SCHEMATIC — BLOCK PLAN, CONCEPT ENVELOPE

LEVEL 1 — OVERALL FLOOR PLAN (REV N)

PROJECT Hazel Green Regional Athletic Complex Trojan Horse Arena · Hazel Green area, Madison County, Alabama (site TBD, D-006)	PHASE PHASE 2	SHEET TITLE OVERALL FLOOR PLAN LEVEL 1 · BLOCK PLAN	SCALE 1" = 40'-0"	DATE October 2026	REV N	DRAWN BY Drawn by KEYSTONE (AI) for Shane Brazelton	SHEET P2-A-101
--	-------------------------	---	---------------------------------------	---------------------------------------	-----------------	---	------------------------------

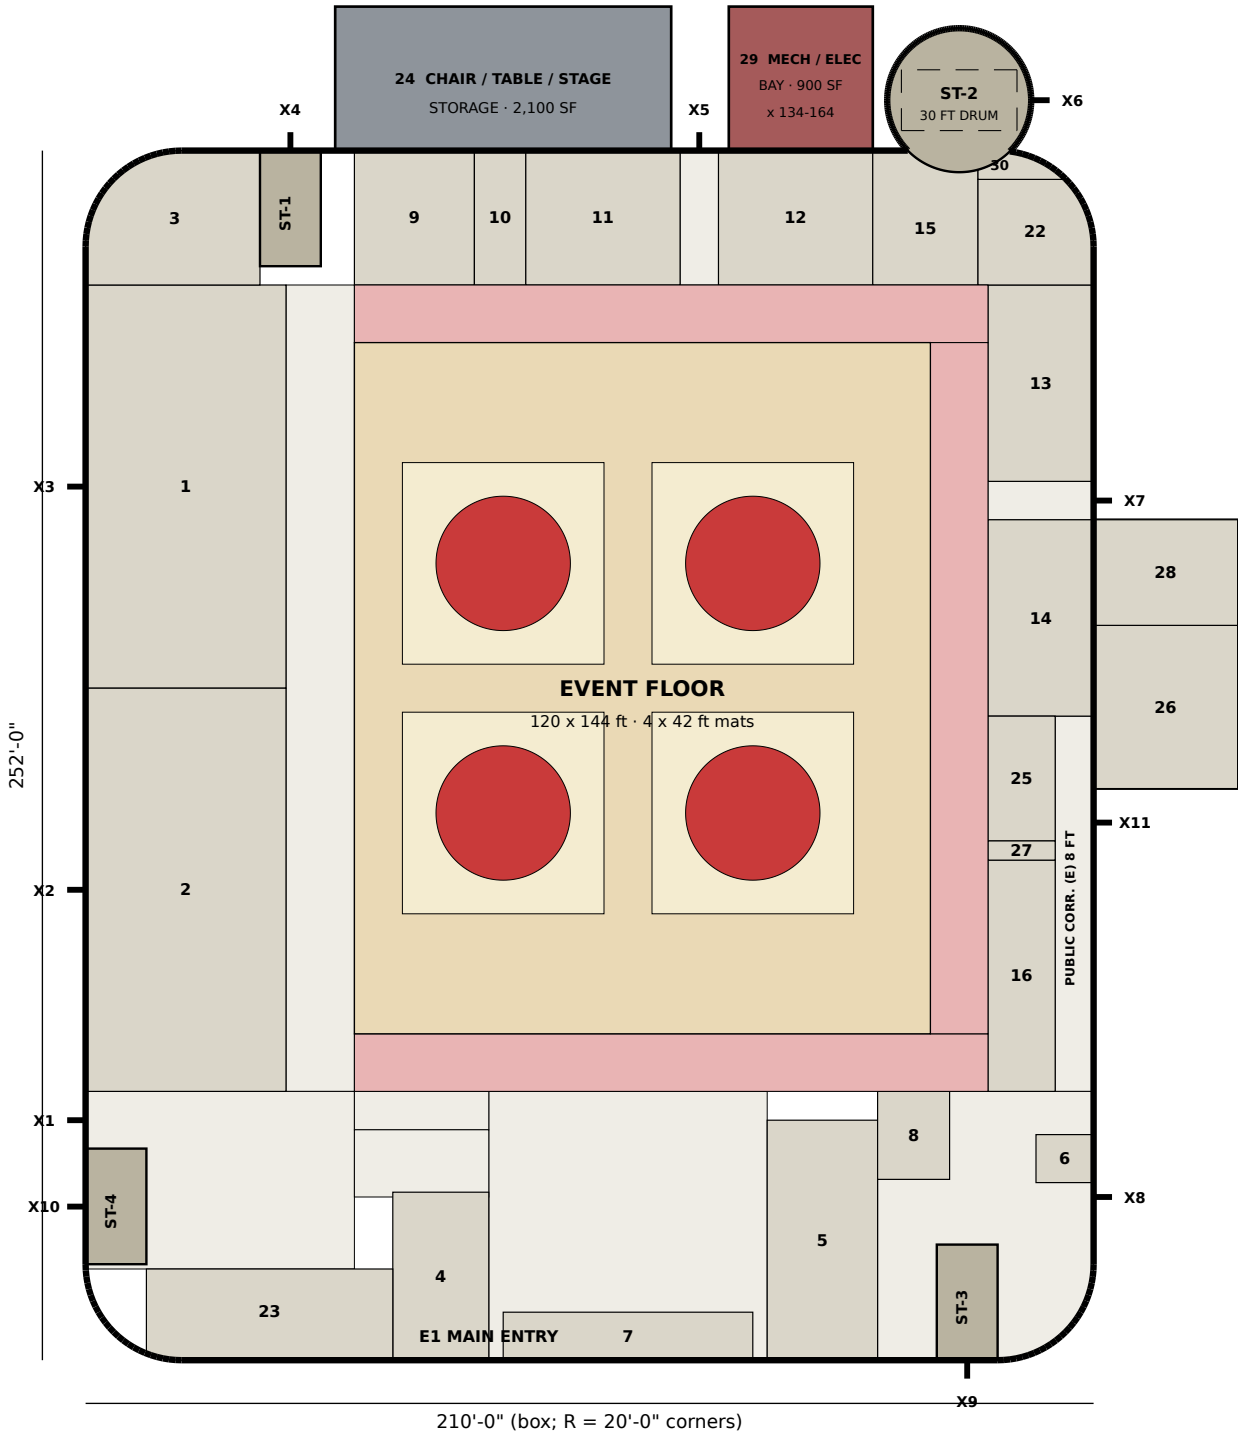
Rev M (30 ft drum D-082, plan Rev J east side D-084) with the old NE stair strip made mechanical (D-086). Nothing else moves; Level 2 (P2-A-102 Rev I) is unchanged.

- 30 MECH (remote): the old ST-2 strip inside the box, x 185.9-204.3, y 246-251.8 (to the drum and the R 20 corner), 67 SF. It does not touch the MECH / ELEC BAY 29 (22.3 ft away), so it is marked remote (D-086). It shares 18.4 ft of wall with MECH (NE) 22 and 2.0 ft with MECH (N) 15. No door drawn; access TBD.
- Mechanical: 4,234 -> 4,302 SF = 4.87 % -> 4.95 % of 86,964 GSF vs 5 % (D-072); 47 SF short. Set Rev D: 4.1 %.
- GSF unchanged: the strip was already inside the envelope.
